Applicant: Lectrosonics, Inc.
581 Laser Road
Rio Rancho, NM 87124

Re: Response to Correspondence reference number 31738

Equipment: FCC ID: DBZSMQM, 731-confirmation number EA290927

Photograph showing separation distance from the back of equipment to the antenna.

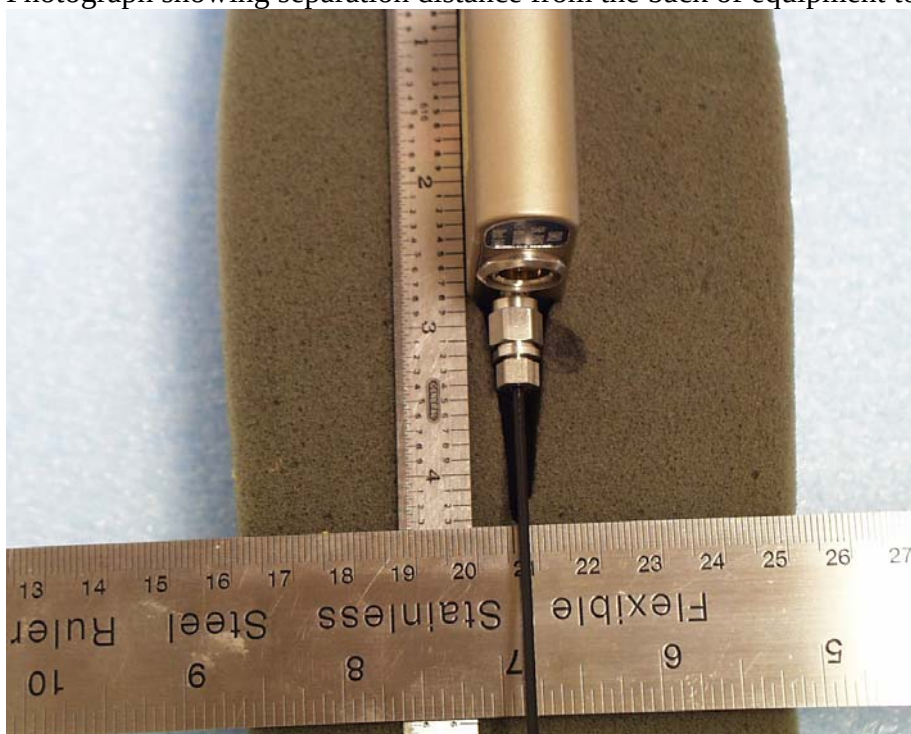
To support FCC RF exposure compliance determination, please submit photos and/or sketches for product with antenna installed showing spacings between the plane of the back of the belt-clip to: a) the back of the device, b) the closest point(s) of installed-antenna(s) FCC will then review all filing info to determine whether other info may need to be requested to support compliance with RF exposure requirements as applicable for all transmitters regulated by FCC. It may help to expedite this review if applicant has available and wishes to voluntarily submit SAR test results for this specific product

Below please find relevant photographs per your request demonstrating spacing between the back of the device and antenna, and the back of the clip and antenna.
